Re: VCAT Ref: P994/2021
Planning Application Number: P/2020/6237
2-8 ST ELMO AVENUE, Ferntree Gully

Amended Plans to VCAT Review

Statement of Changes to Plans

PROPOSED SITE PLAN & DESIGN RESPONSE
SCALE: 1 : 250

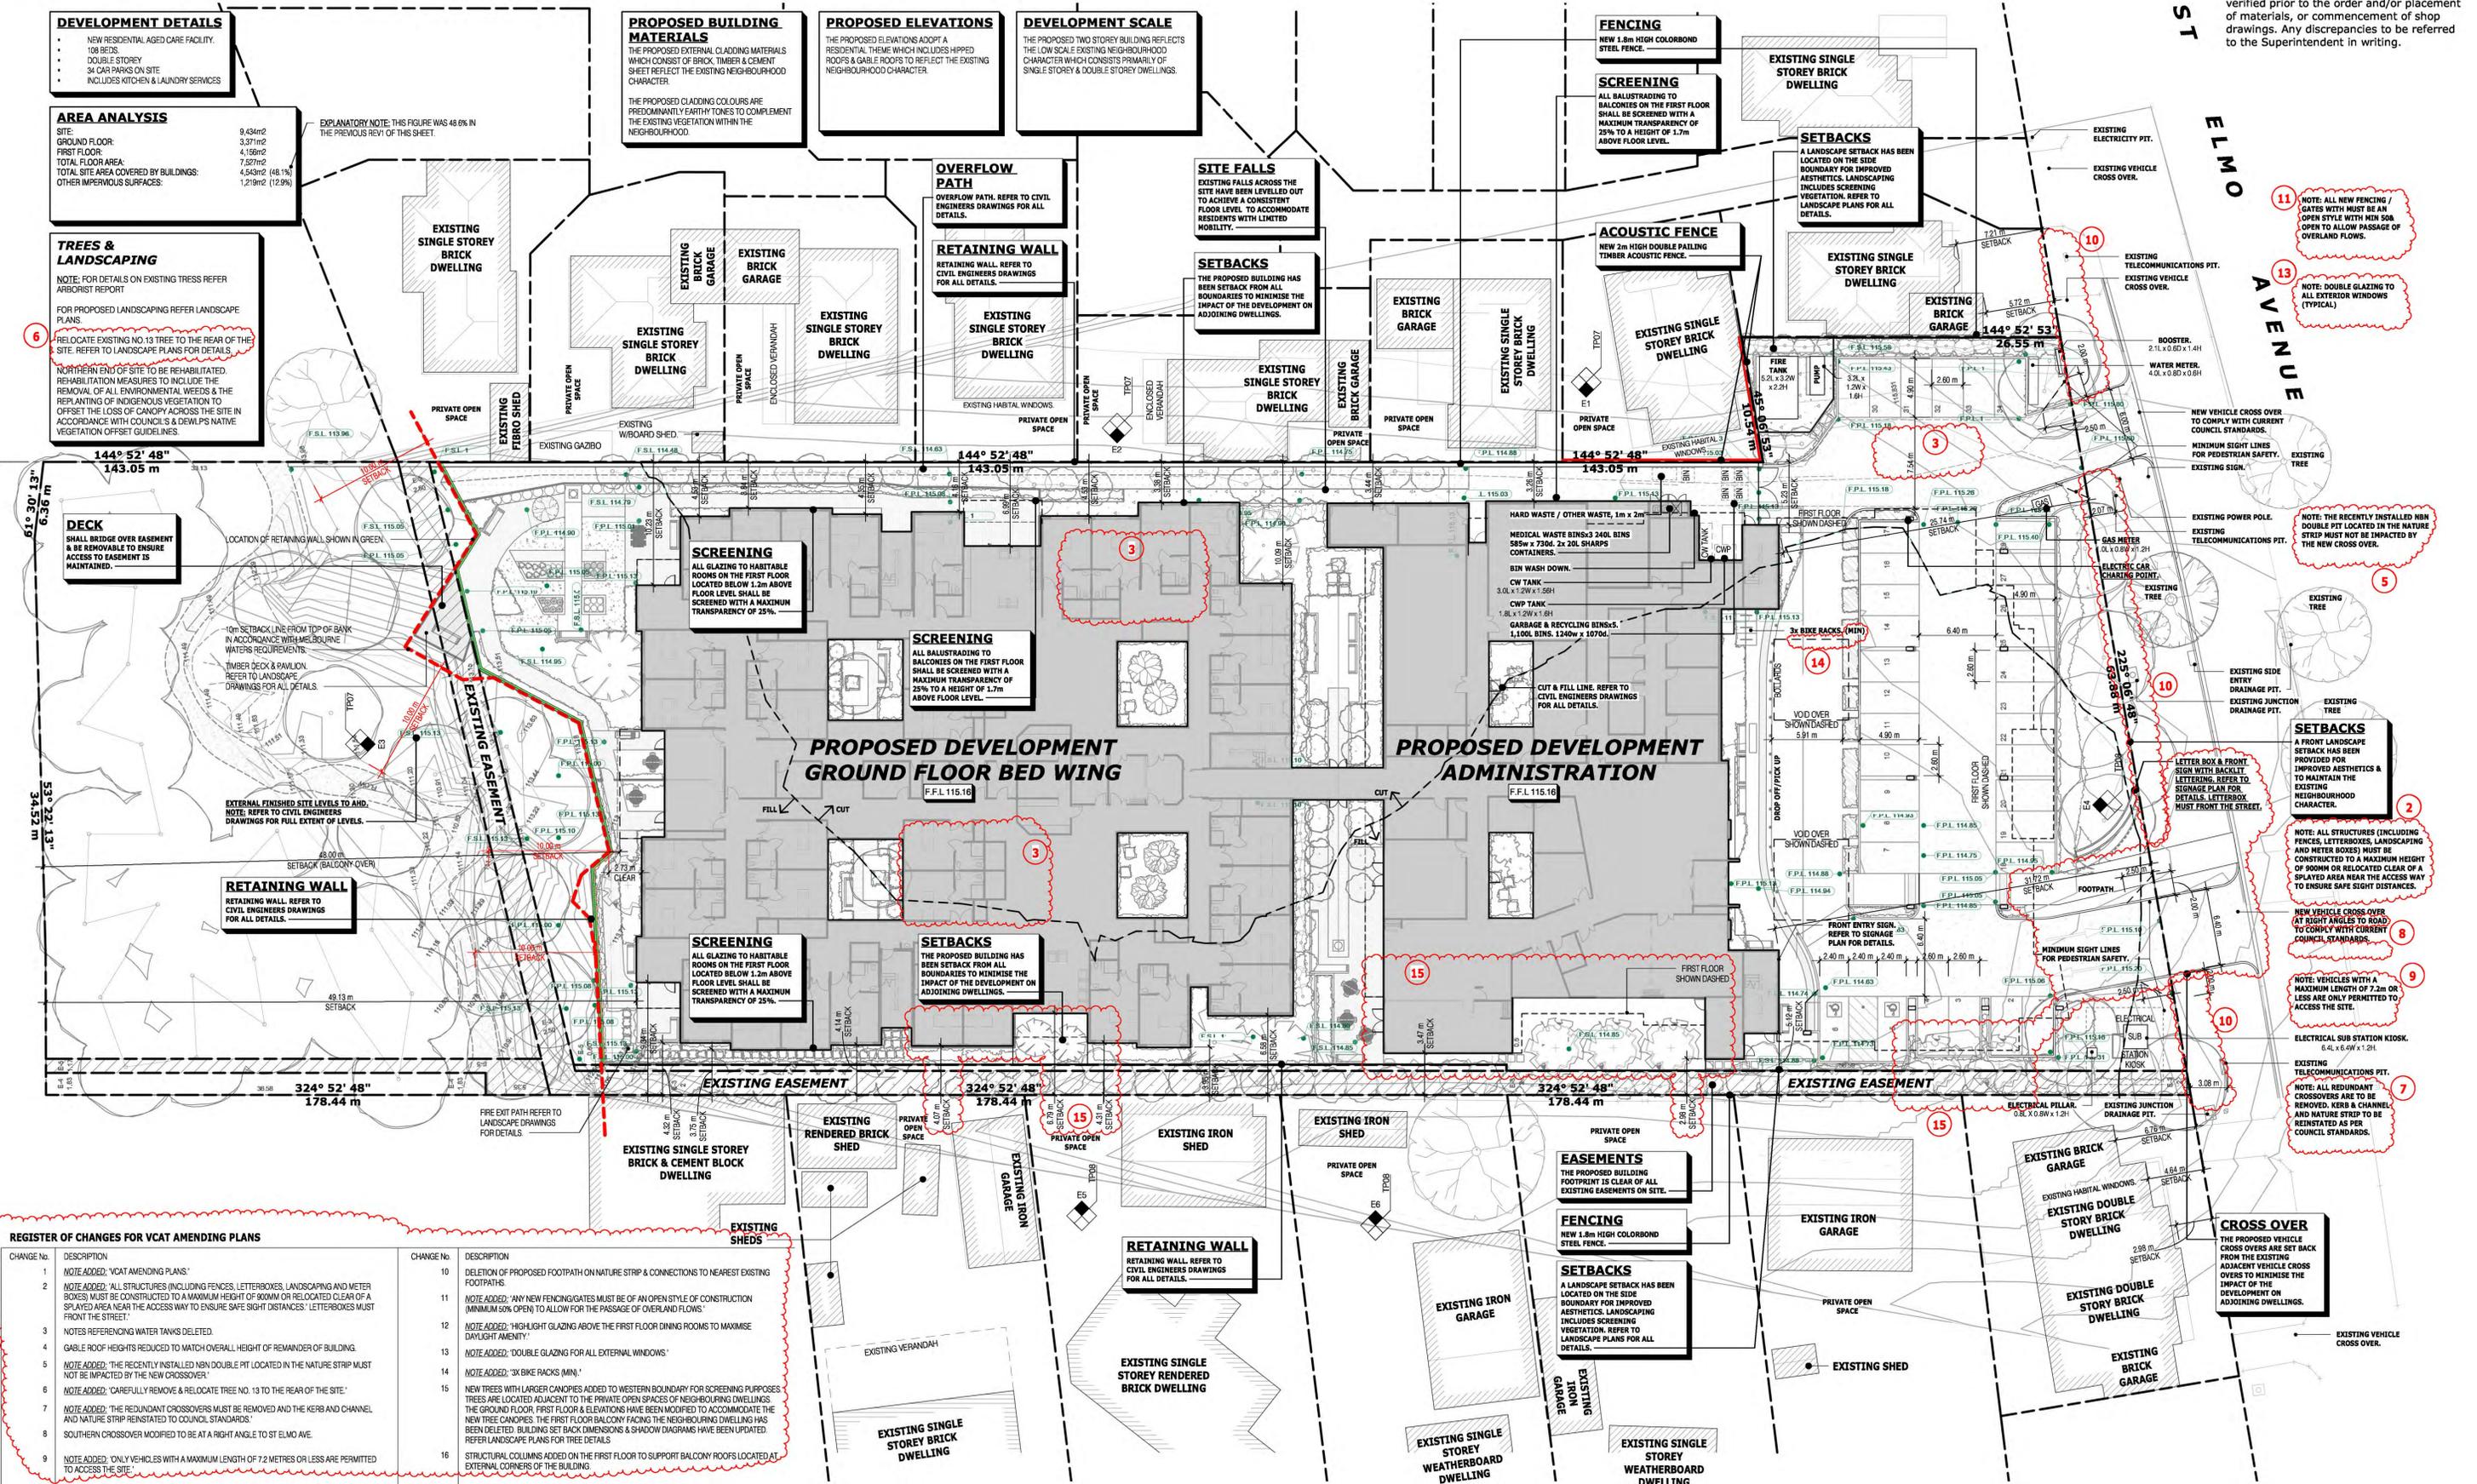
CHANGE No.	DESCRIPTION	DRAWING No.
1	Note added: 'VCAT amending plans.'	All sheets
2	Note added: 'All structures (including fences, letterboxes, landscaping and meter boxes) must be constructed to a maximum height of 900mm or relocated clear of a splayed area near the access way to ensure safe sight distances.' Letterboxes must front the street.'	TP03, TP04, TP13
3	Notes referencing water tanks deleted.	TP03, TP04

4	Gable roof heights reduced to match overall height of remainder of building.	TP07, TP08, TP09, TP11, TP12, TP13, TP14
5	Note added: 'The recently installed NBN double pit located in the nature strip must not be impacted by the new crossover.'	TP03, TP04
6	Note added: 'Carefully remove & relocate tree no. 13 to the rear of the site.'	TP02, TP03
7	Note added: 'The Redundant crossovers must be removed and the kerb and channel and nature strip reinstated to Council standards.'	TP03, TP04
8	Southern crossover modified to be at a right angle to St Elmo Ave.	TP03, TP04, TP05
9	Note added: 'Only vehicles with a maximum length of 7.2 metres or less are permitted to access the site.'	T003, TP04
10	Deletion of proposed footpath on nature strip & connections to nearest existing footpaths.	T003, TP04
11	Note added: 'Any new fencing/gates must be of an open style of construction (minimum 50% open) to allow for the passage of overland flows.'	TP03, TP04, TP07, TP08, TP09

12	Note added: 'Highlight glazing above the First Floor dining rooms to maximise daylight amenity.'	TP07, TP08
13	Note added: 'Double glazing for all external windows.'	TP03, TP04, TP05, TP07, TP08, TP09
14	Note added: '3x bike racks (min).'	TP03, TP04

PROPOSED GROUND FLOOR PLAN
SCALE 1 : 200

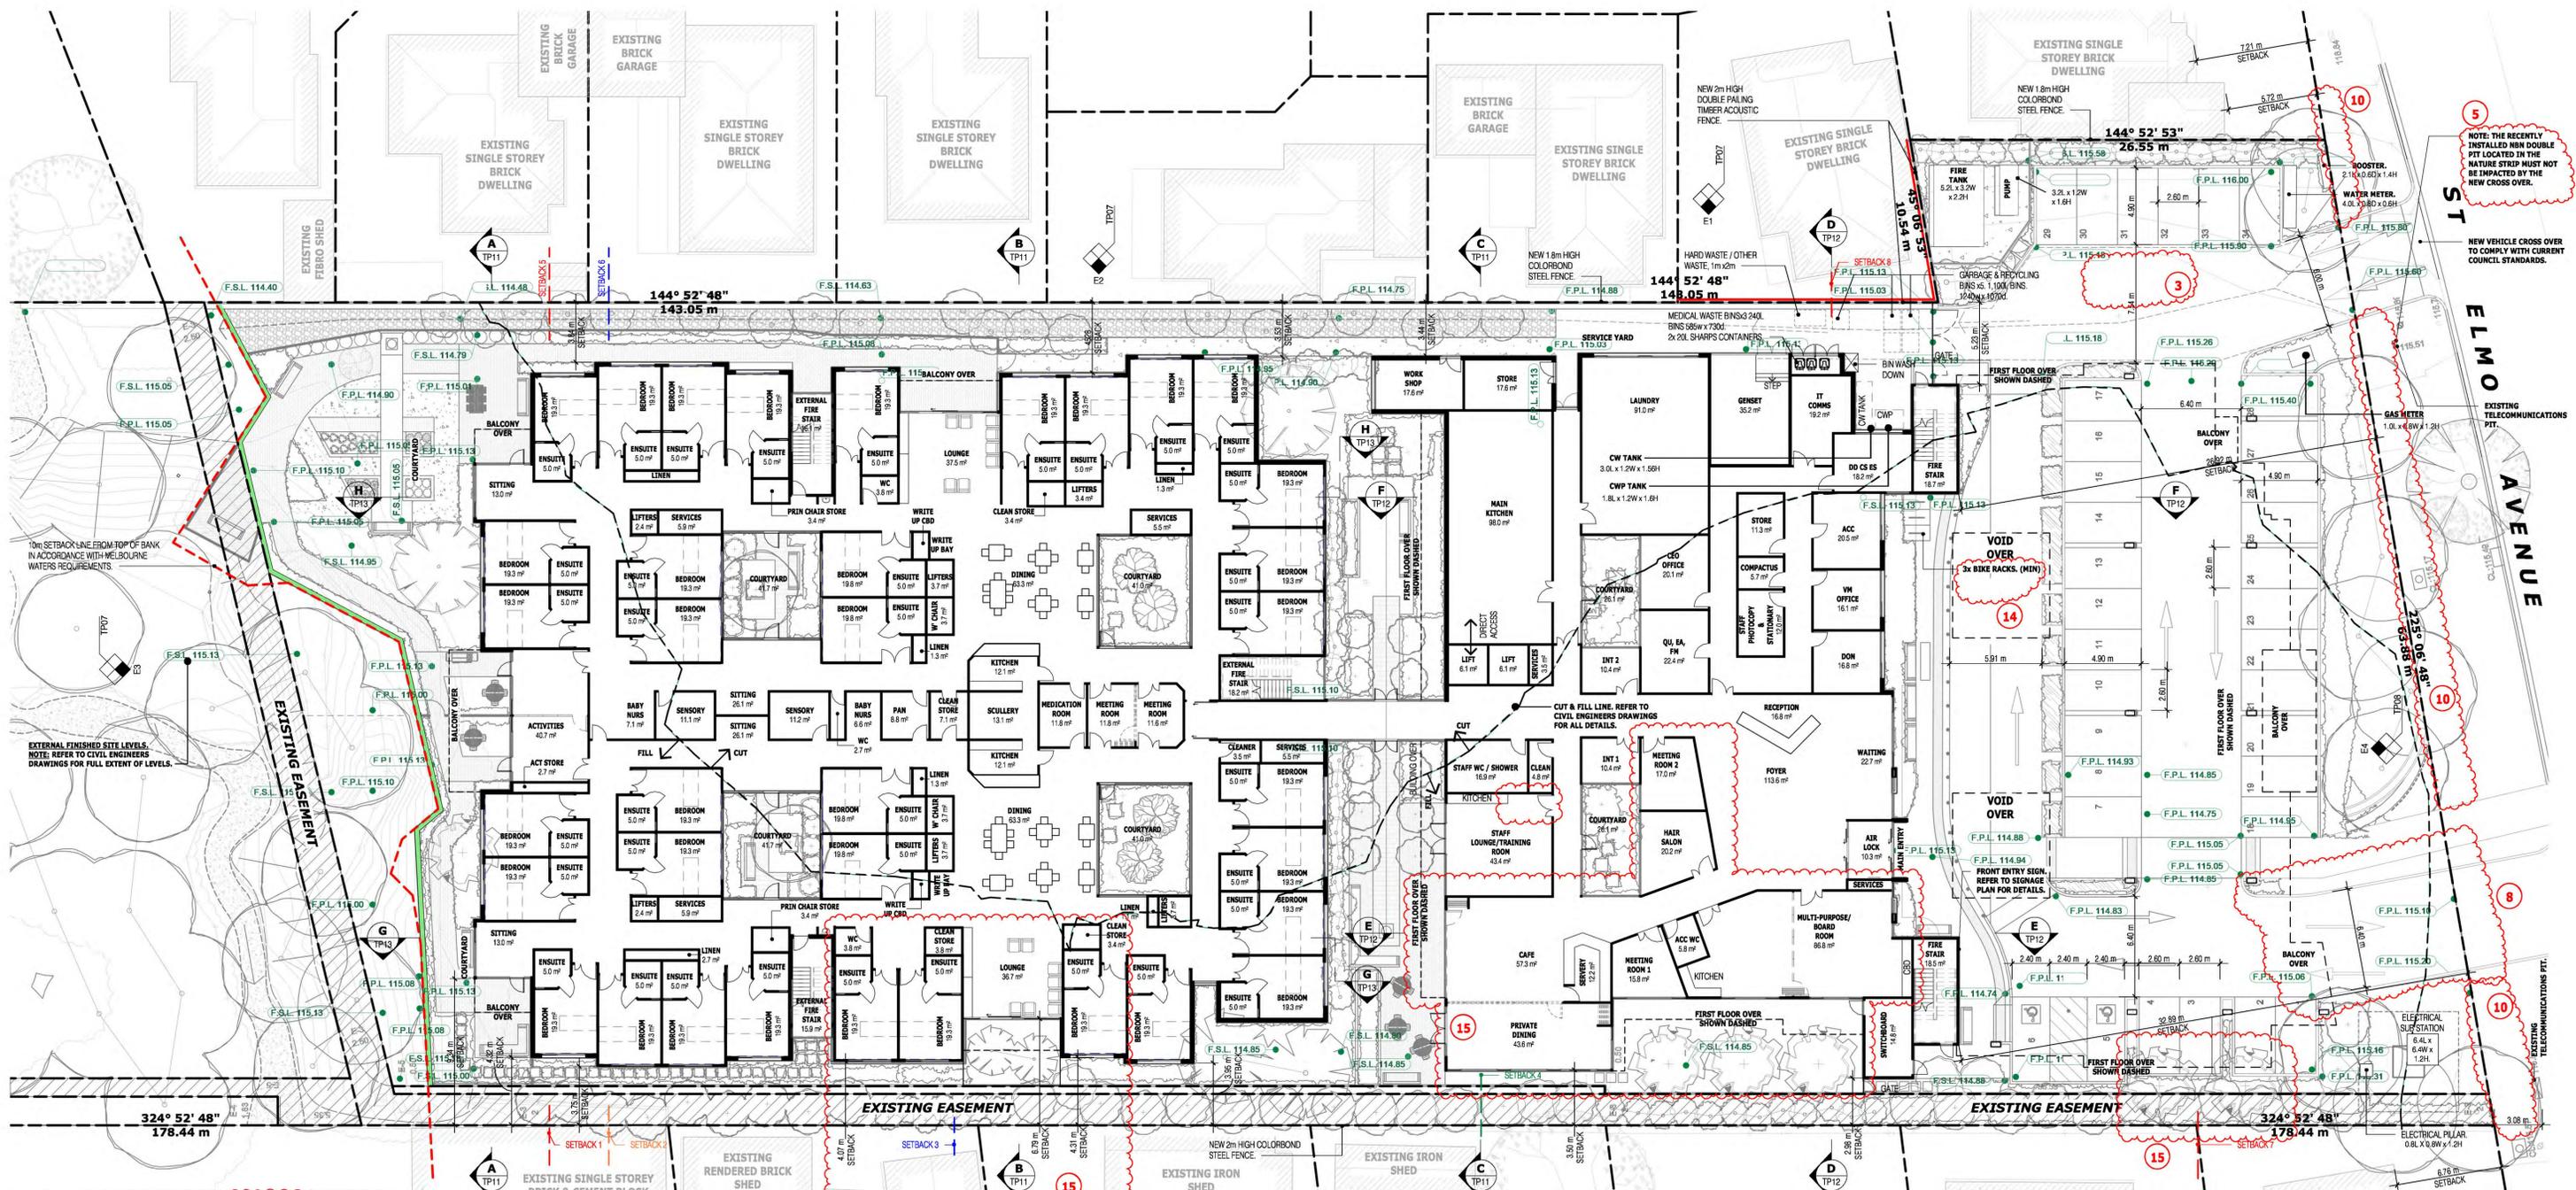
- NOTE: ALL NEW FENCING / GATES MUST BE AN OPEN STYLE WITH MIN 50% OPEN TO ALLOW PASSAGE OF OVERLAND FLOWS.
- NOTE: ALL STRUCTURES (INCLUDING FENCES, LETTERBOXES, LANDSCAPING AND METER BOXES) MUST BE CONSTRUCTED TO A MAXIMUM HEIGHT OF 900MM OR RELOCATED CLEAR OF A SPRAWLED AREA NEAR THE ACCESS WAY TO ENSURE SAFE SIGHT DISTANCES.

- NOTE: ALL REDUNDANT CROSSOVERS ARE TO BE REMOVED. KERB & CHANNEL AND NATURE STRIP TO BE REINSTATED AS PER COUNCIL STANDARDS.
- NOTE: DOUBLE GLAZING TO ALL EXTERIOR WINDOWS (TYPICAL).

- NEW VEHICLE CROSS OVER TO COMPLY WITH CURRENT COUNCIL STANDARDS. VEHICLES WITH A MAXIMUM LENGTH OF 7.2M OR LESS ARE PERMITTED TO ENTER THE SITE.
- NEW VEHICLE CROSS OVER AT RIGHT ANGLES TO ROAD TO COMPLY WITH CURRENT COUNCIL STANDARDS.

PROPOSED FIRST FLOOR PLAN

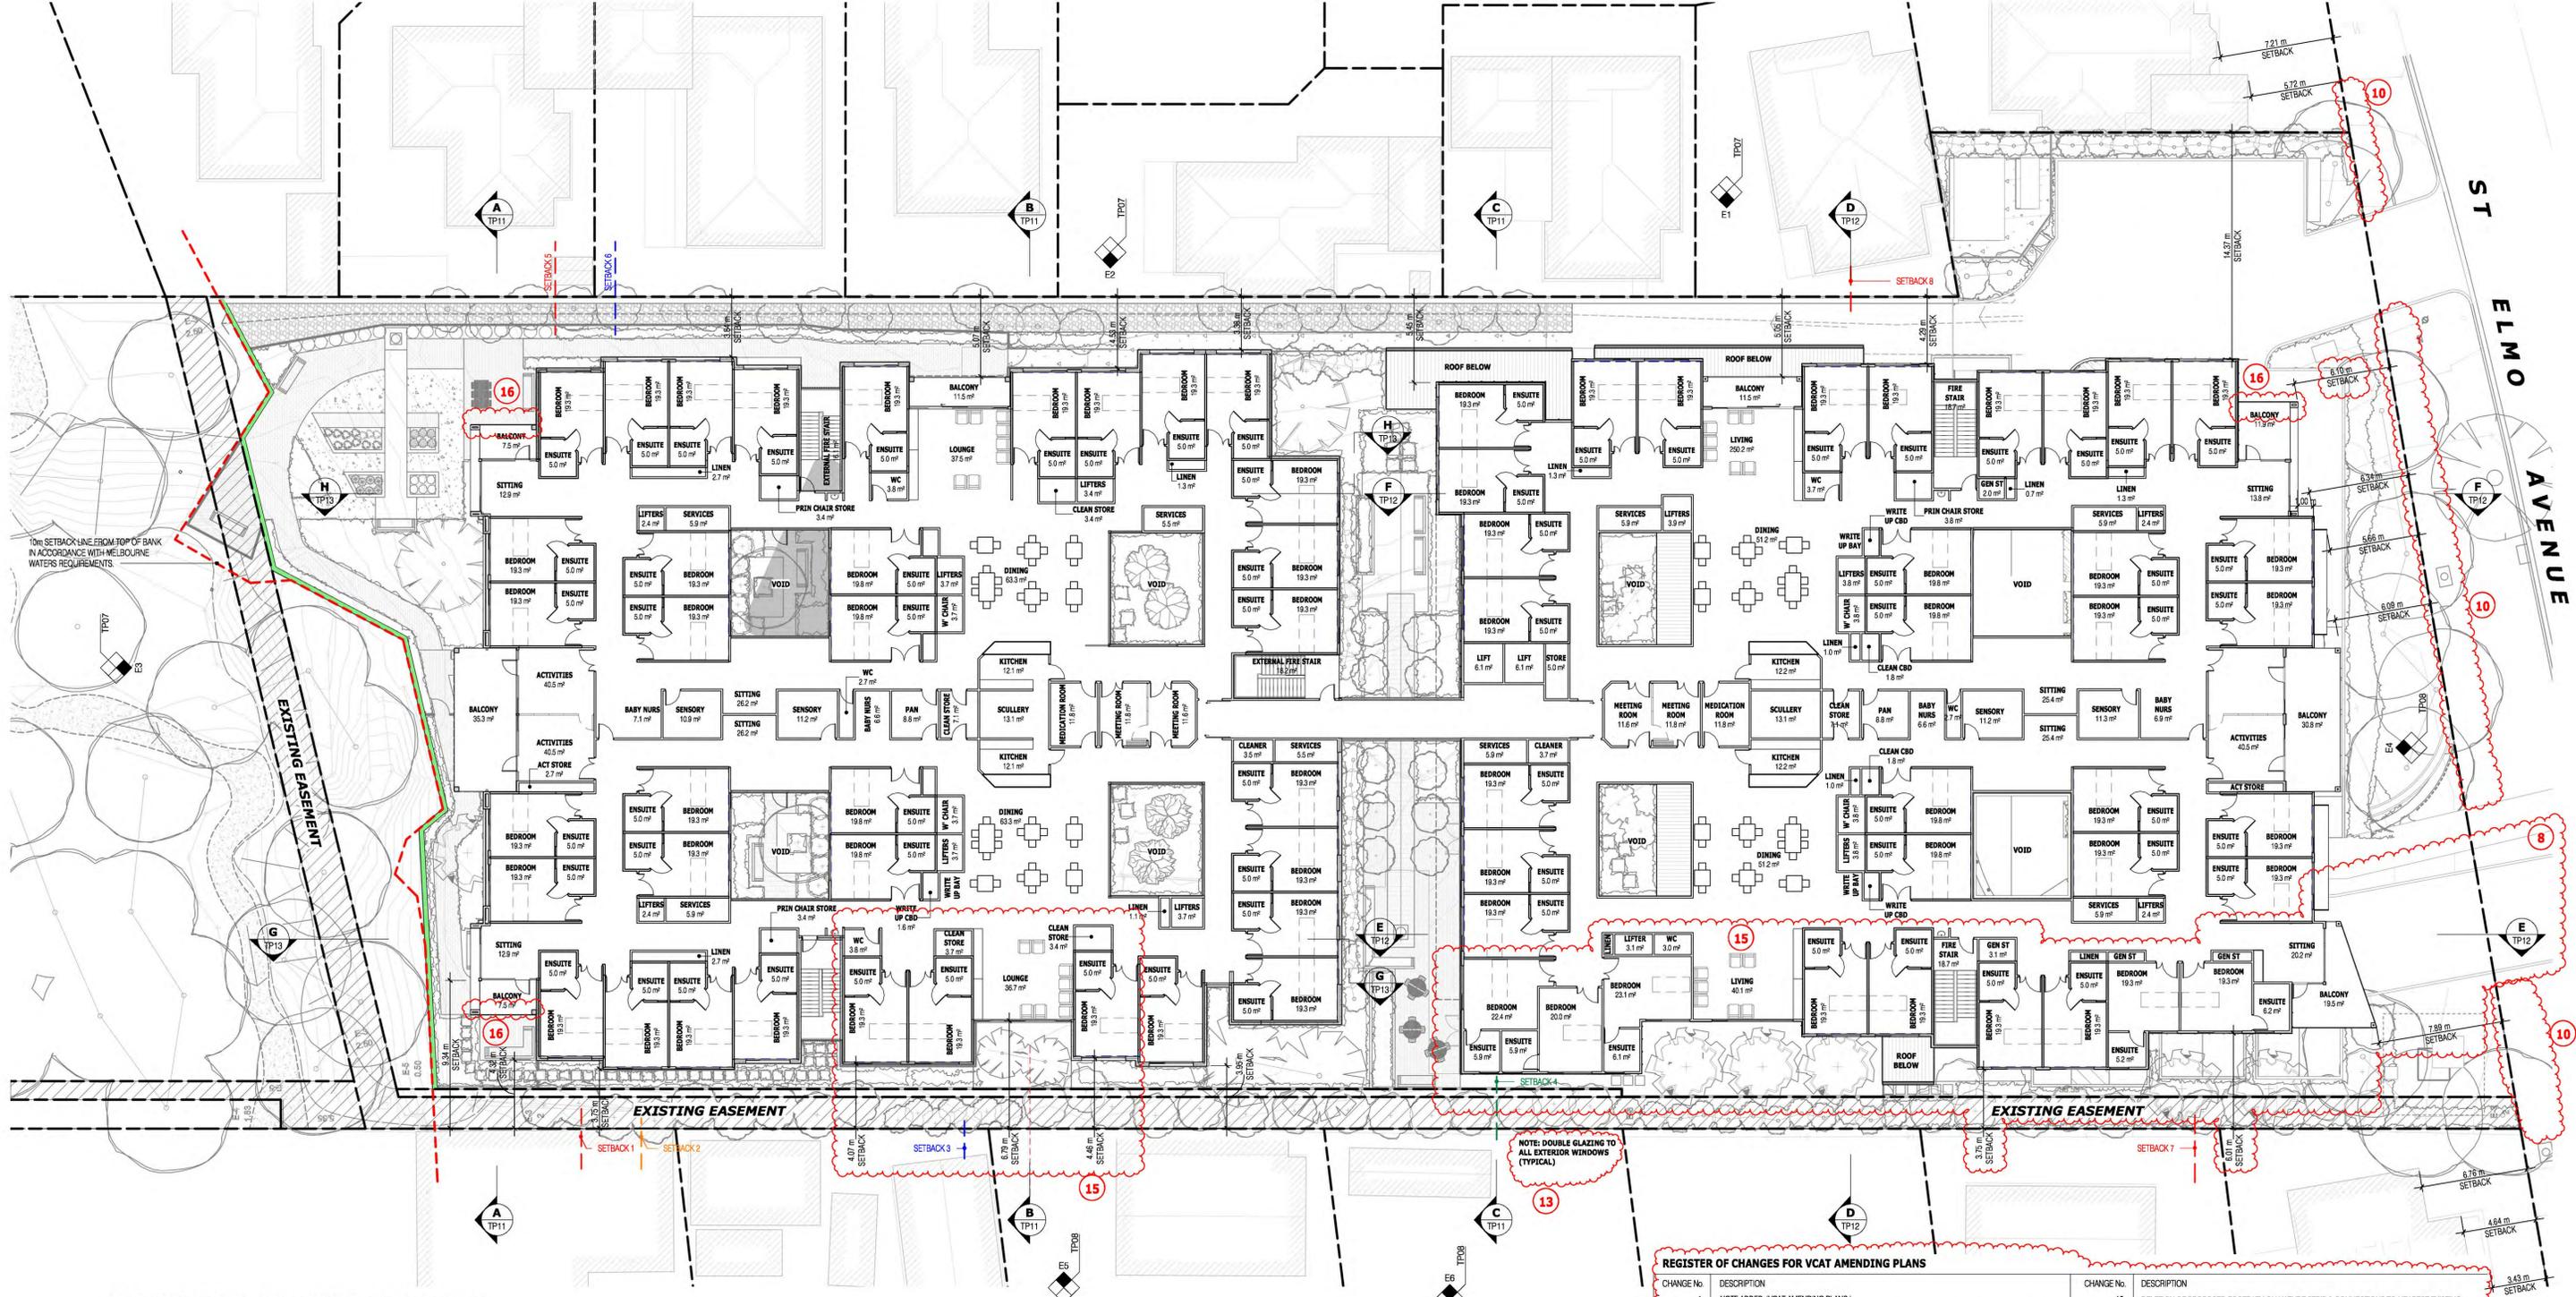
15	New trees with larger canopies added to western boundary for screening purposes. Trees are located adjacent to the private open spaces of neighbouring dwellings. The ground floor, first floor & elevations have been modified to accommodate the new tree canopies. The first floor balcony facing the neighbouring dwelling has been deleted. Building set back dimensions & shadow diagrams have been updated. Refer landscape plans for tree details.	TP03, TP04, TP05, TP06, TP08, TP09, TP11, TP12, TP14
16	Structural columns added on the first floor to support balcony roofs located at external corners of the building.	TP05, TP07, TP08, TP09
